KENWOOD

SERVICE BULLETIN

PS-50 IMPROVED VOLTAGE SURGE PROTECTION

AVR UNIT (X43-1520-00) Component Side

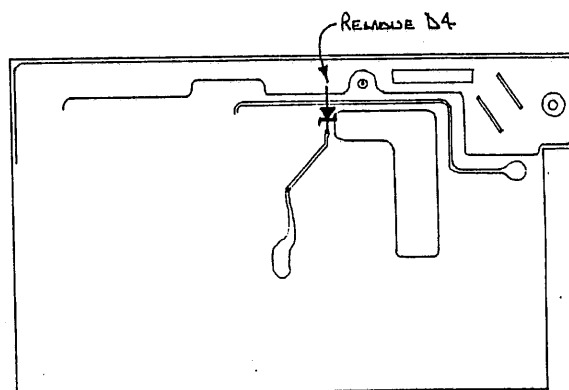
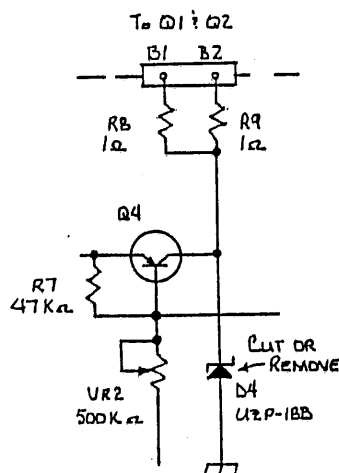
We have received a few reports regarding the loss of transistor Q4, resistors R2, and R3, and zener diode D4 on the AVR UNIT. Apparently a voltage surge on the power input might cause D4 to short. If this occurs the surge current thru resistors R2 and R3 could be high causing the failure of the two resistors and Q4.

On the AVR UNIT (X43-1520-00) open or remove diode D4. The drawings below show the location of this component.

If you receive a unit with no output voltage check D4, R2, R3, and Q4. You should replace R2, R3, and Q4 if there is any sign of damage to any of these components.
